PROJECT NAME
WALGREENS STORE
(RWC) PASEO DEL NORTE & VENTURA
ALBUQUERQUE, NM

DRAWING TITLE
INTERIM DRAINAGE MANAGEMENT PLAN

**Re: Paseo del Norte and Ventura Blvd Development, Drainage Management Plan
Engineer's Stamp dated 11-9-09 (D20/D010)**

Re: Walgreens, Paseo del Norte and Ventura Blvd, Grading Plan
SO-19 Permit on Rough Rider Rd
Engineer's Stamp dated 4-21-09 (D20/D010)

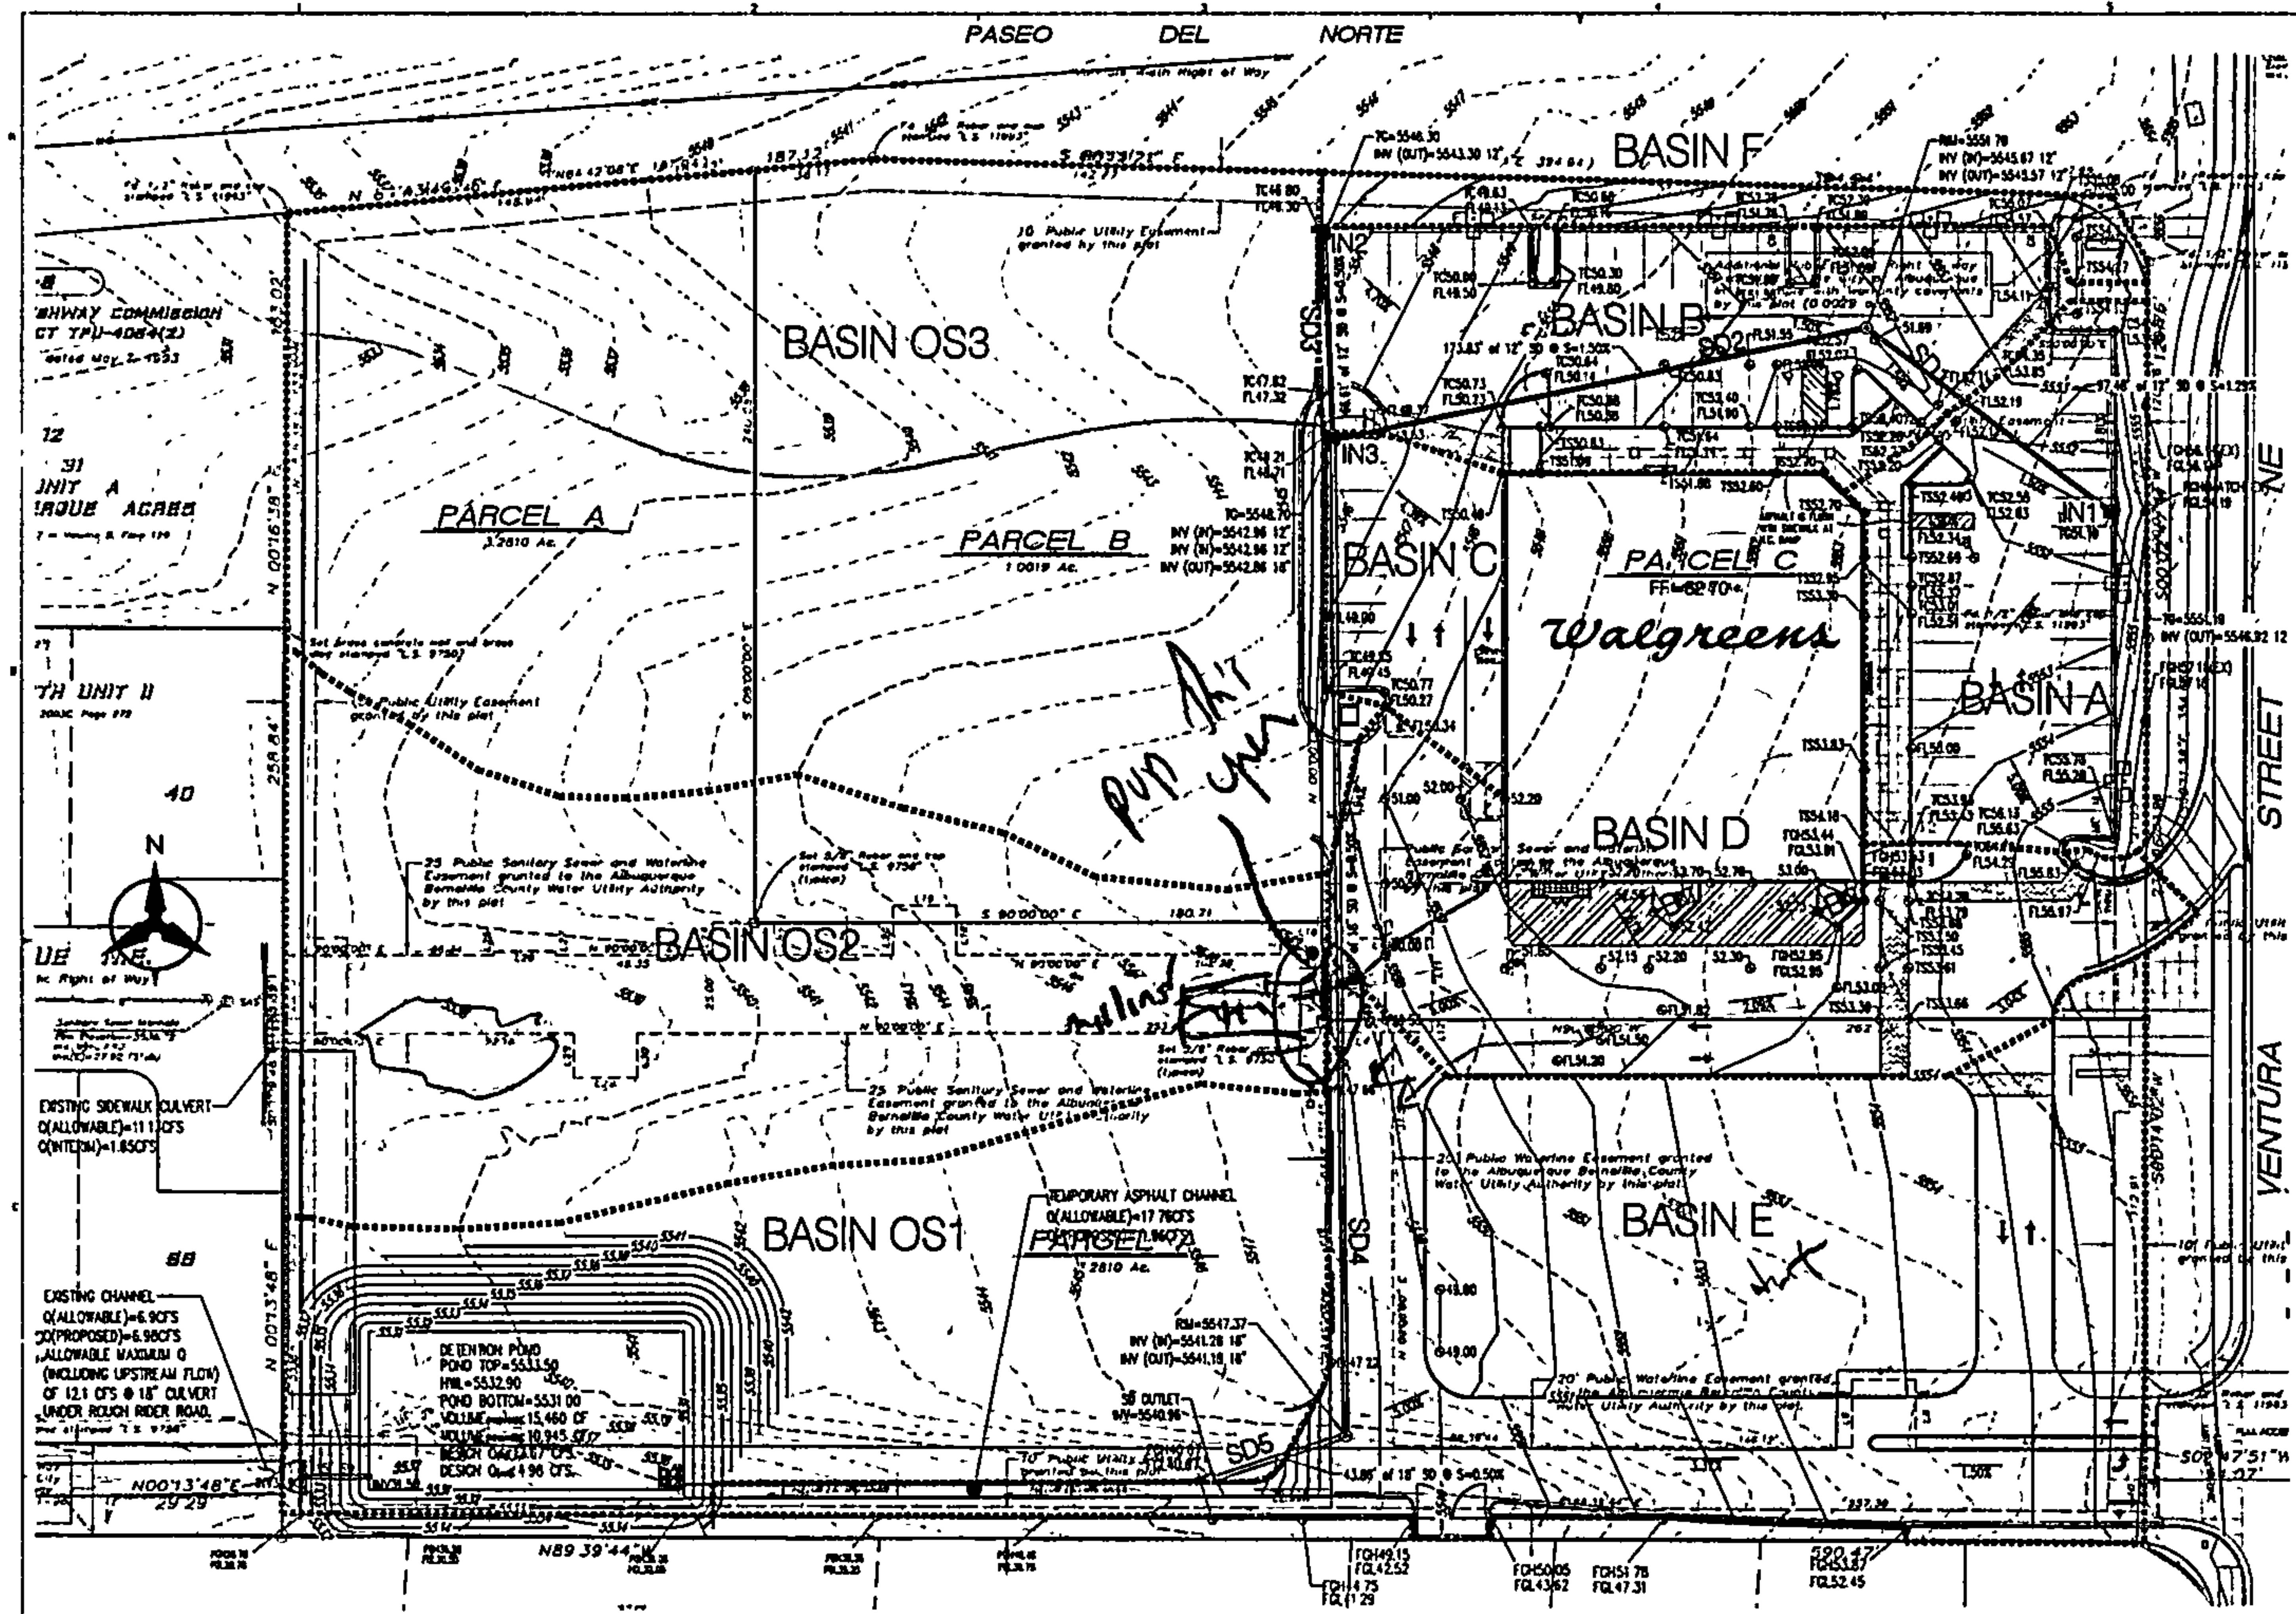
Tell - "BHA Stamp a plan that doesn't work and Rough Rider"

21,859 ft³ ~ 5000 ft³ 10.1
2105 ft³
 $\frac{10}{500 \text{ ft}^2 \times 2' = 250'}$

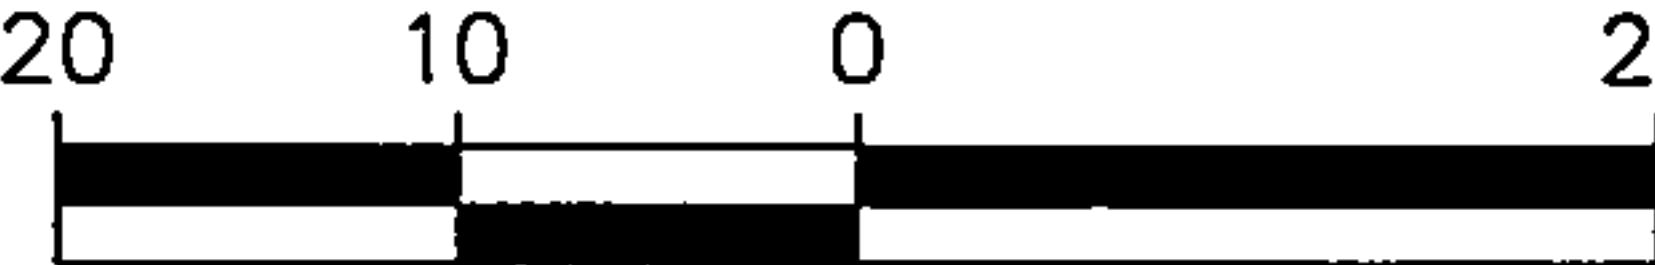
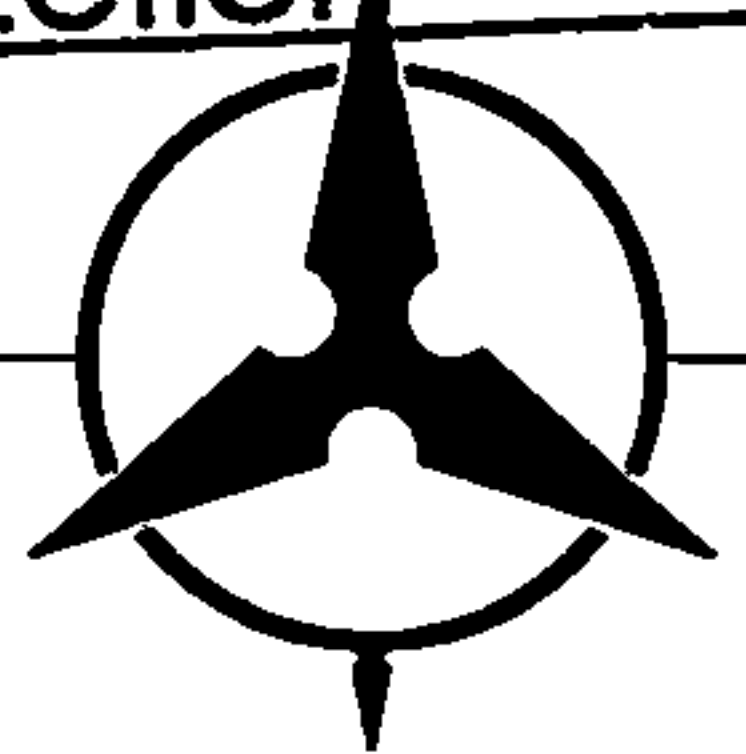
Based upon the information provided in your submittal received 11-9-09, the above referenced plan is approved as the Drainage Management Plan for this development with the comment that Basin C should have been included in the list of Basins draining to the Paseo del Norte system in the narrative.
